SP2024-032

PROJECT COMMENTS

PROJECT NAME: Site Plan for 855 Whitmore Drive

CASE CAPTION: Discuss and consider a request by Hooman Sedaghat of Buildeng, LLC on behalf of Salvador Salcedo for the approval of a Site Plan

TD1

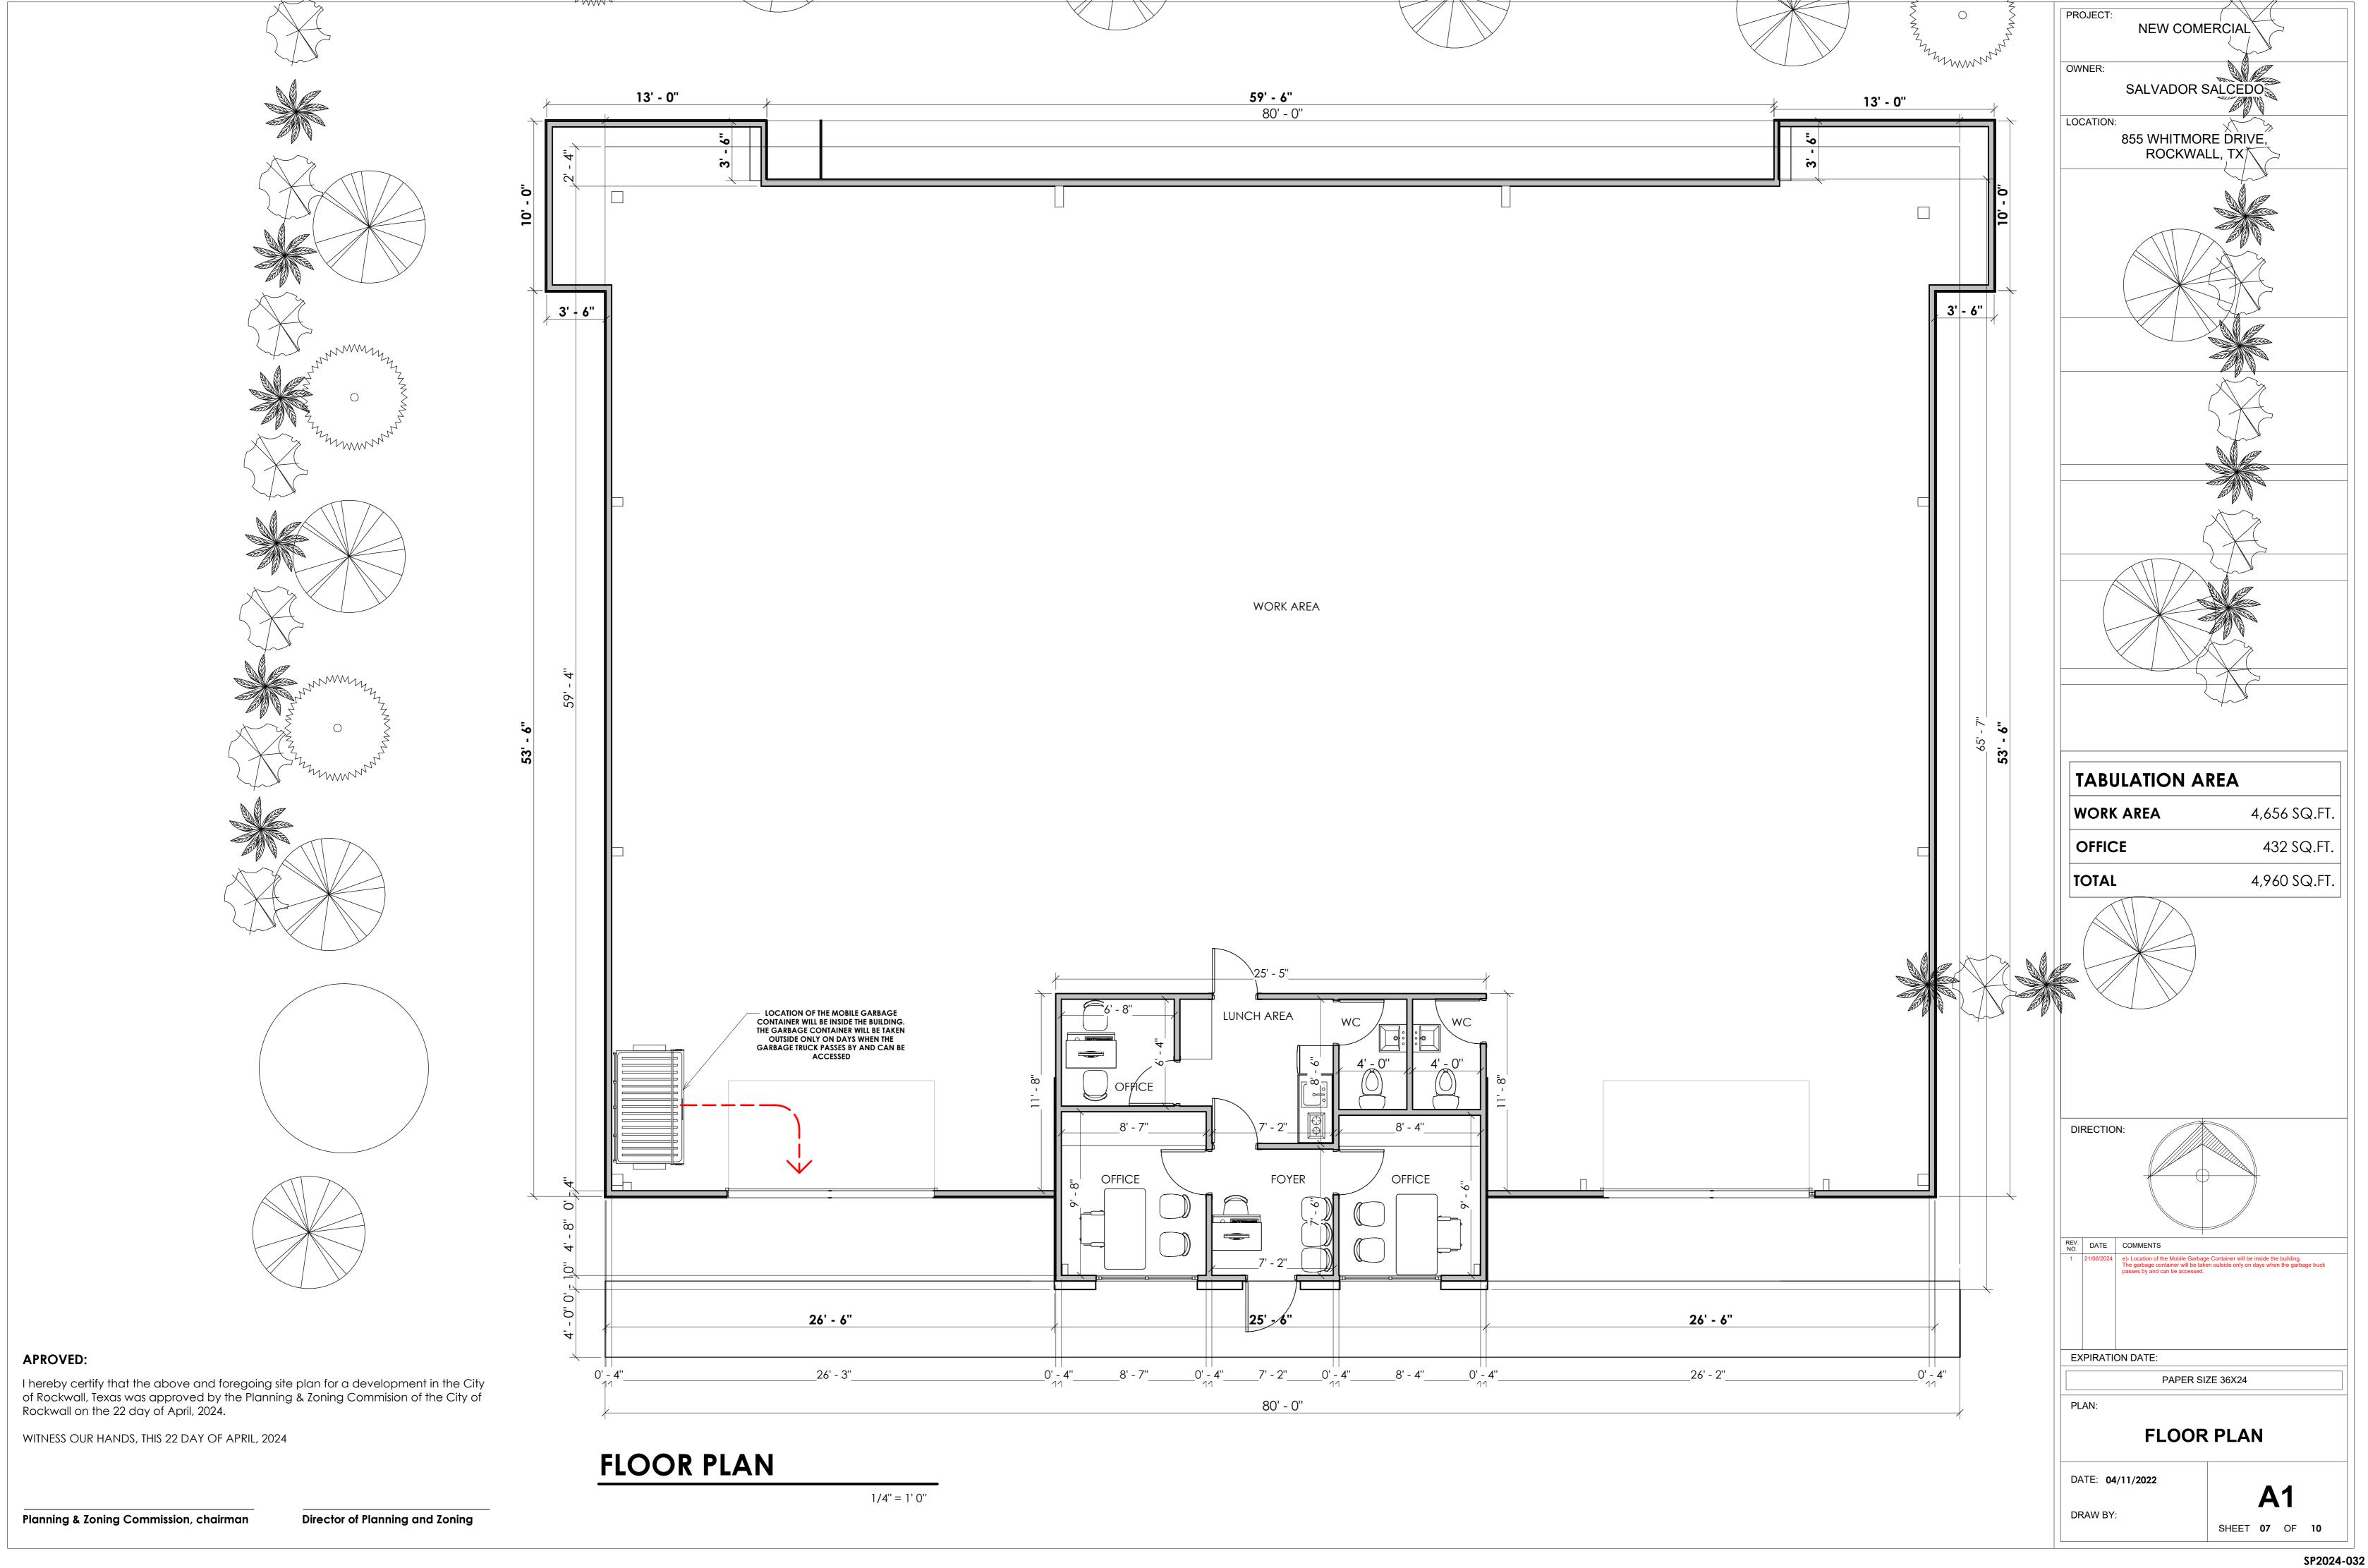
M.8 Treescape Plan

(1) The applicant is removing 40 caliper inches and planting 148 caliper inches. Given this, the mitigation is satisfied. (Section 05, of Article 09, UDC)

SITE PLAN

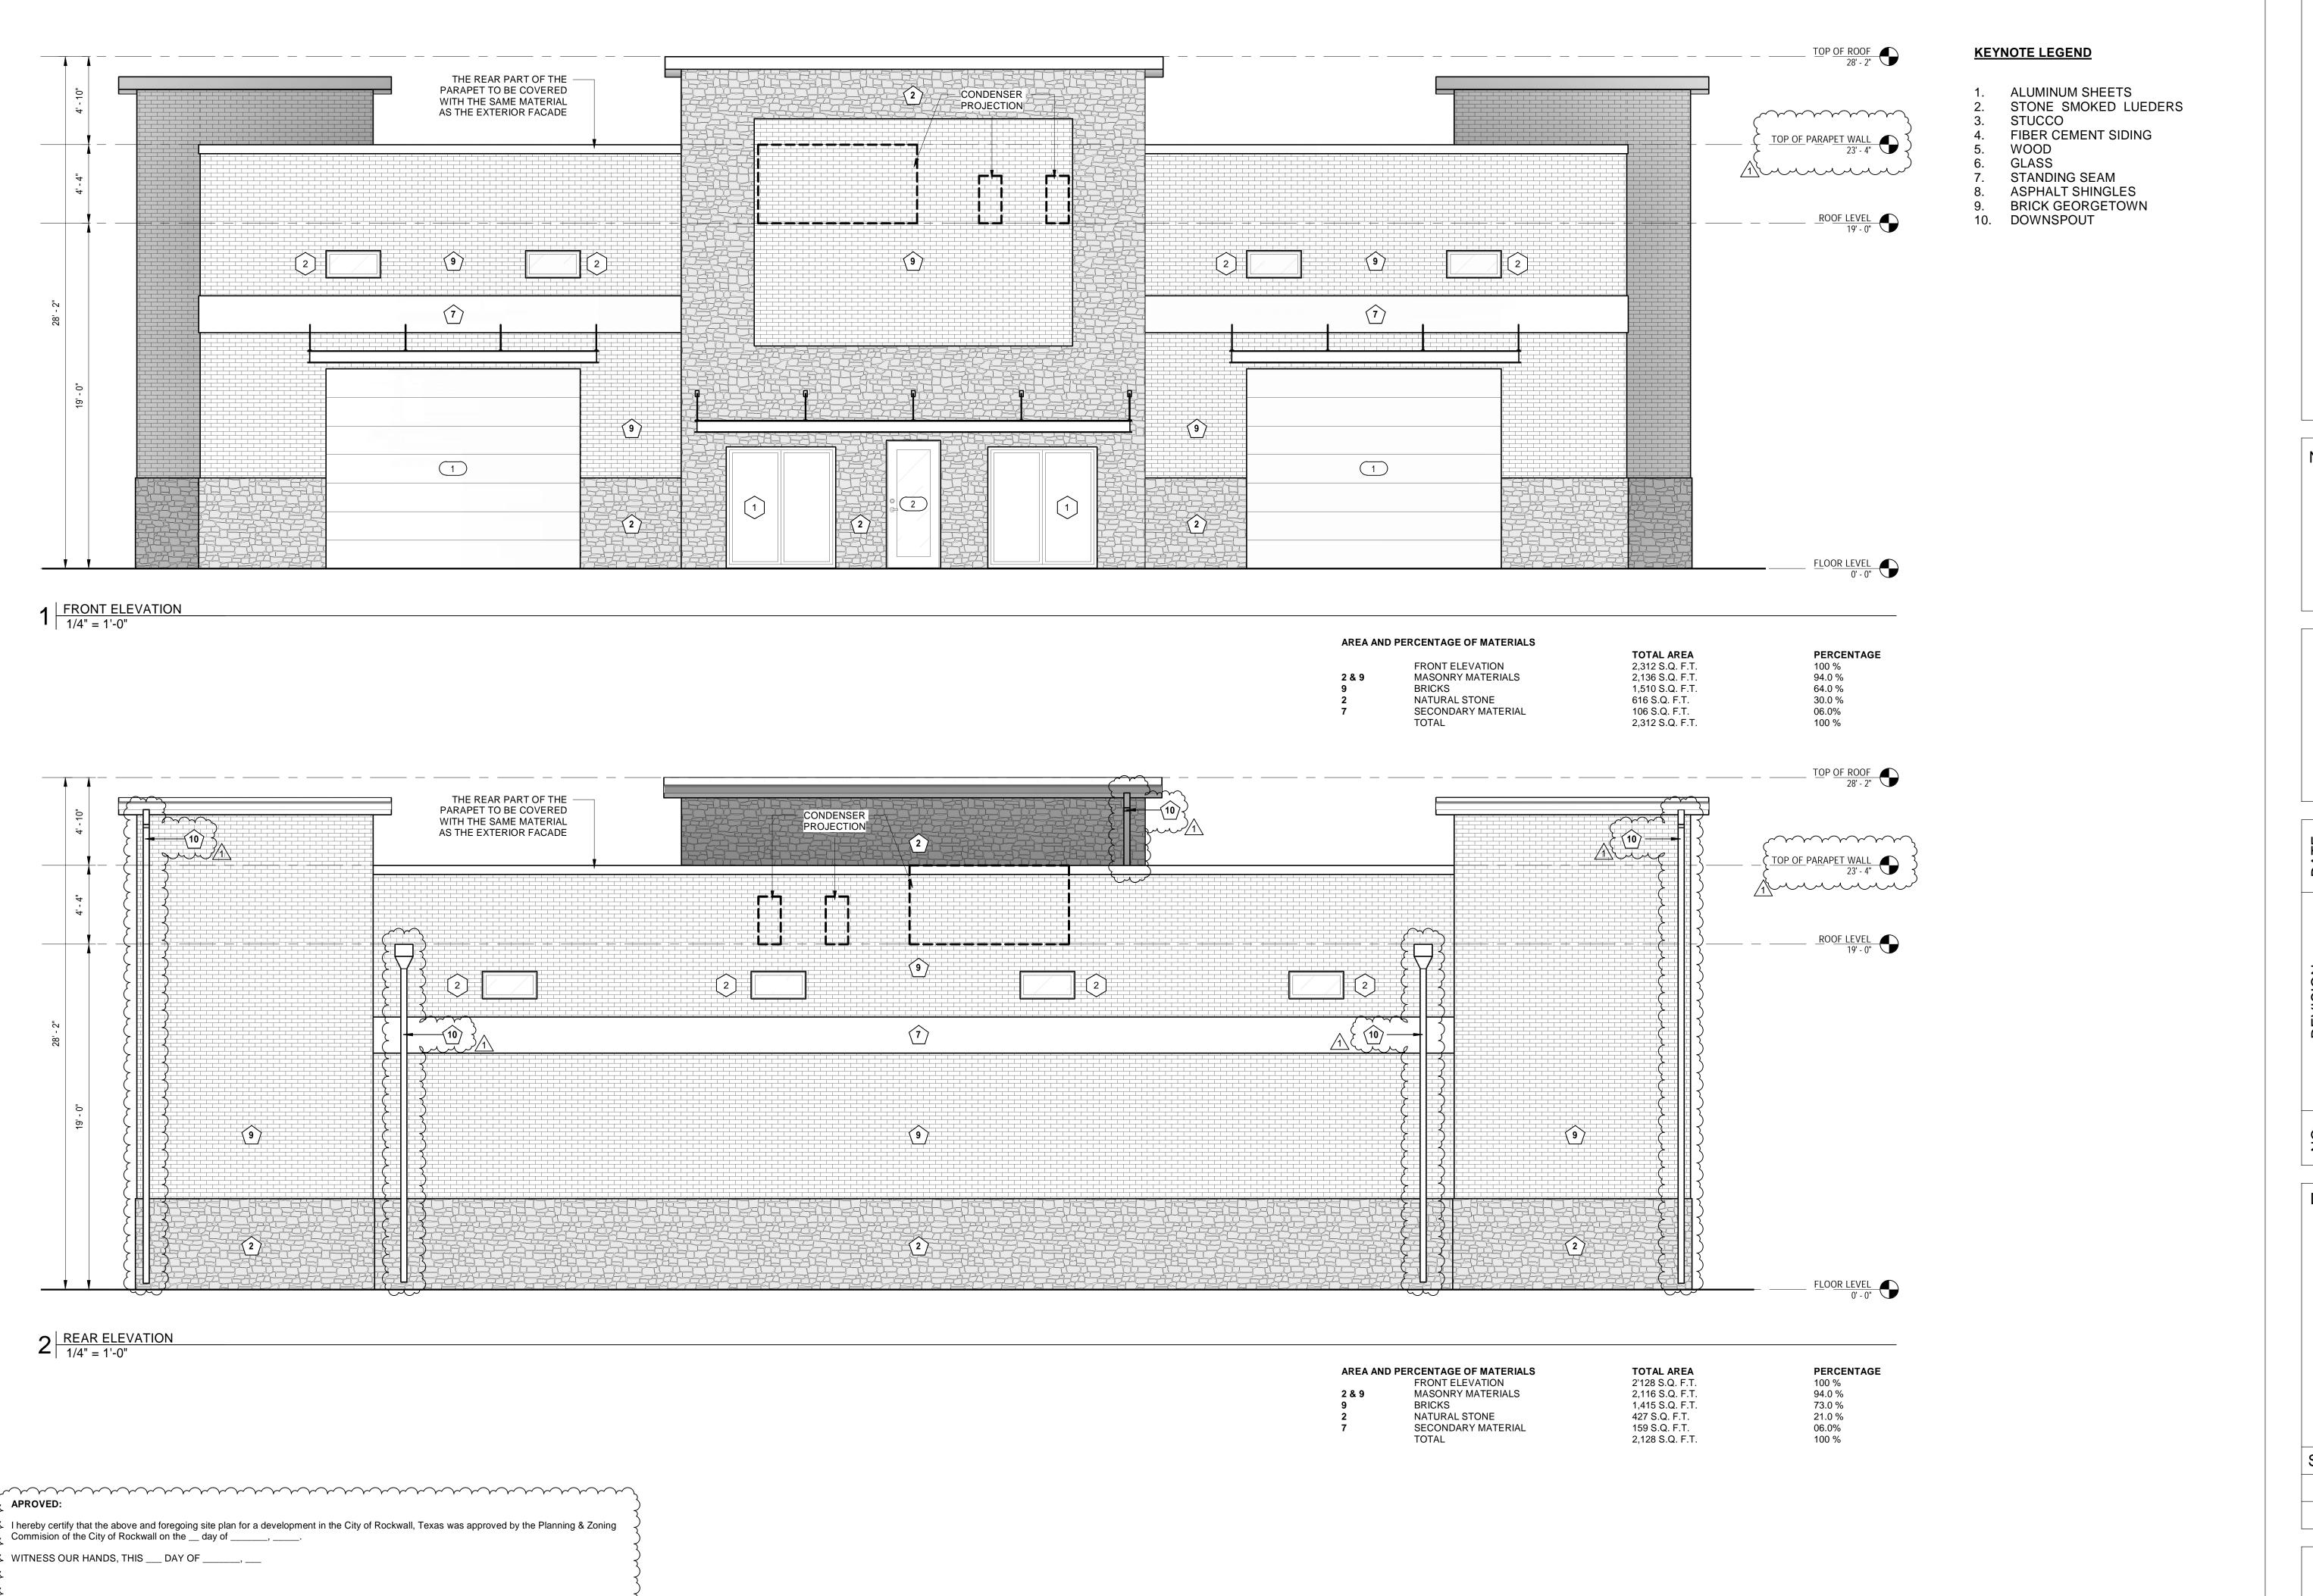
M.6 Site Plan.

- (1) Please include the Owner and Developer information (i.e. name, address, and phone number). (Subsection 03.04. B, of Article 11, UDC)
- (2) Please indicate the adjacent street right-of-way. (Subsection 03.04. B, of Article 11, UDC)
- (3) Please provide a parking table that details the required parking per use. Office is 1 space per 300 SF and Manufacturing is 1 space per 500 SF. (Subsection 05.01, of Article 06,

- (4) Please indicate the type and depth of the paving material and provide a detail or cut-sheet. All required parking and loading areas shall be constructed of concrete, but may have a surface treatment of brick, stone or other similar material. (Subsection 03.02, of Article 06, UDC)

- (5) Signage is done through separate permits with the Building Inspections Department. (Subsection 06.02. F, of Article 05, UDC)
- (6) Please indicate if there will be gates. If so, please provide a detail. All fences must be constructed as a masonry wall, or be wrought iron. A picket metal fence is not permitted. In addition, please remove the note indicating that no fence is proposed. (Subsection 08.02. F, of Article 08, UDC)

- (7) Off-street loading docks must be screened from all public streets and any residential district that abuts or is directly across a public street or alley from the lot. The screening must be at least six feet in height and may be provided by using a masonry fence, berms, plantings or a combination of the above. In this case, the bay doors face directly onto Whitmore Drive and cannot be screened. Given this, this will require an exception from the Planning and Zoning Commission. Staff should note, this exception is one reason this case was denied previously. (Subsection 01.05. A, of Article 05, UDC)
